DATE: June 26; 11:00 am – 12 noon

End of Field Report No. Two

Photo #6: A replacement stone was laid between two second floor window sills. The new stones should align with the adjacent existing stones.

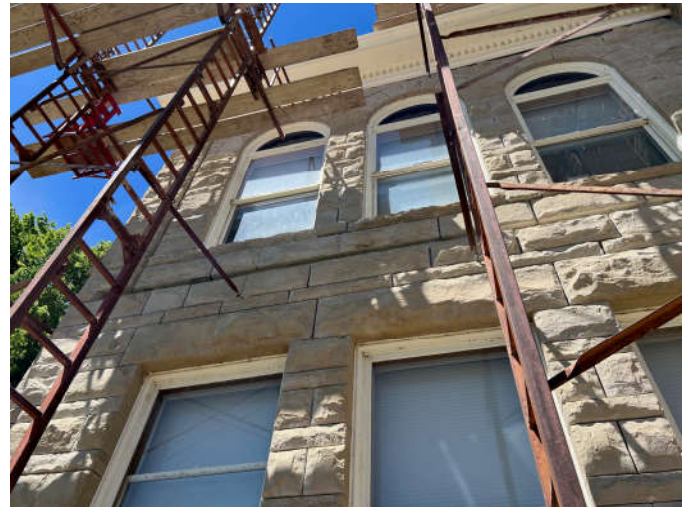
4. A replacement stone was provided between two window sills on the second floor. It should be laid to align with the adjacent stone sills rather than at the original projected (uneroded) location. (Re: Photo #6.)
5. An existing vent on the south wall of the main east entry should be retained.
6. Mike indicated that the project will be completed by the beginning of November.
